CITY OF BELOIT

REPORT TO THE BELOIT LANDMARKS COMMISSION

File Number: COA-2012-02

Location: 743 Park Avenue

Damaged siding and trim on east side of the property.

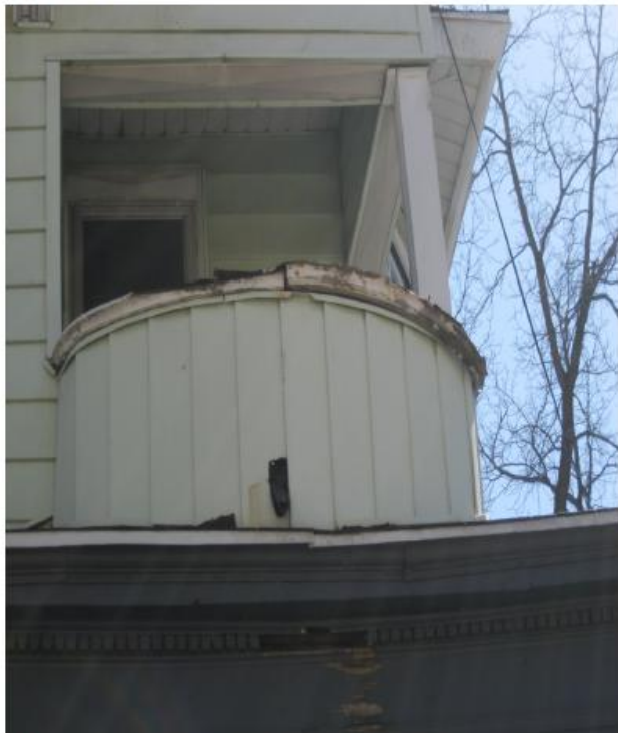
- The applicant has proposed to replace the deteriorated vinyl siding on the basement entryway, located on the east side of the house, with new Main Street Double 4" Woodgrain Clapboard vinyl siding from Certain Teed Corporation. The new vinyl siding will match the existing "mint" color and woodgrain texture siding on the house. In addition, siding near the driveway entry, located on the north side of the house, will be replaced with salvaged pieces of siding from the basement entryway.

Damaged siding and trim on east side of the property. Photograph taken by Code Inspector on March 30, 2011.

1. The applicant shall install Main Street Double 4” Woodgrain Clapboard vinyl siding that is “mint” in color in a workmanlike manner.
2. The applicant shall remove the unauthorized white aluminum soffit and fascia panels and verify with the Code Inspector that deteriorated wooden soffit and fascia boards have been repaired or replaced in a workmanlike manner.

Figure 1: Project Description Submitted By Applicant

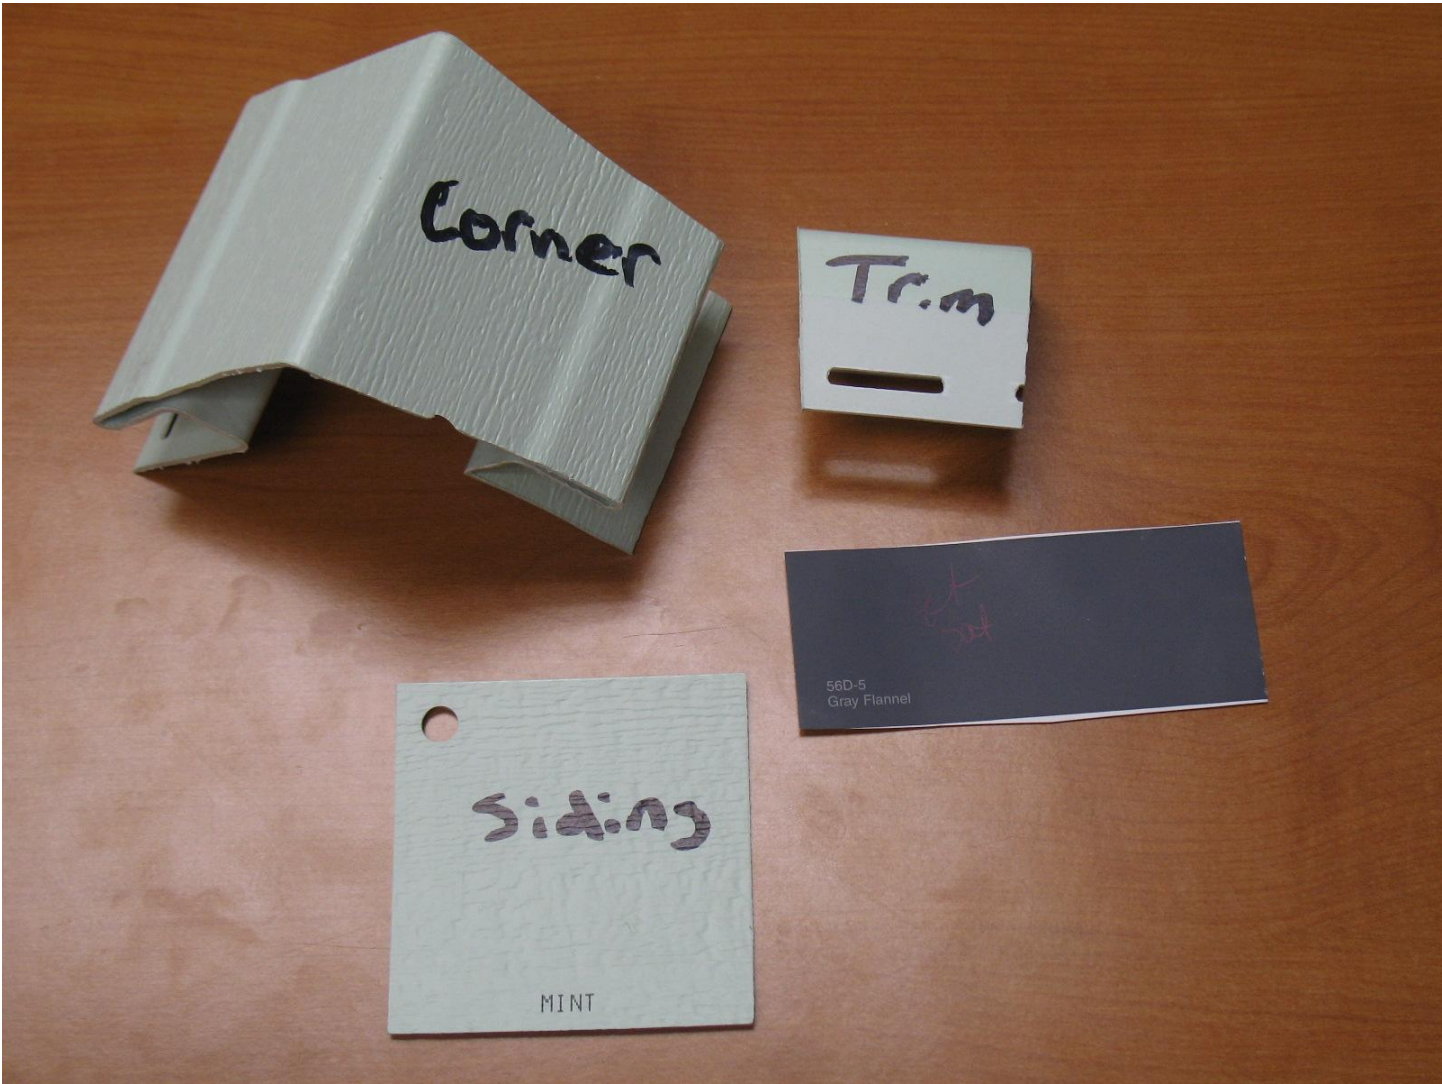
1. Paint Front porch and stairs.
Keep same color that is already there. (See attached picture)
Stairs and spindles to get painted and remain white. Porch floor to stay grey
Cost of materials <\$100

2. Replace soffit and fascia
Work has already been done. Recovered wood with aluminum where the wind had blown of the aluminum that was already there. (See attached picture)
Used the same aluminum and color (white) that covers the rest of the house.
Cost of materials <\$75

3. Recover trim on balcony
Work has already been done. Recovered trim with new aluminum to replace the aluminum that was bent/missing. (See attached picture)
Used the same aluminum and color (white) that covers the rest of the house.
Cost of materials \$5

4. Replace and paint ornamental trim on the veranda.
Work has already been done. Replaced veranda to match identically to what was there. Need to paint and will match up color to existing structure. (See attached picture)
Also included is a sample of the paint color.
Cost of materials \$15

5. Replace and repair siding, corner pieces and trim pieces.
Would like to replace all of the siding on the basement stair entry way. The basement stairs are located on the back side of the house. I would then use the pieces from the basement stair entry way to fix the other pieces of siding that need replacing. All pieces that I would be replacing are on the back and driveway side of the house. Only a couple of pieces are located on the driveway side. The majority of the pieces are located on the back of the house. (See attached picture)
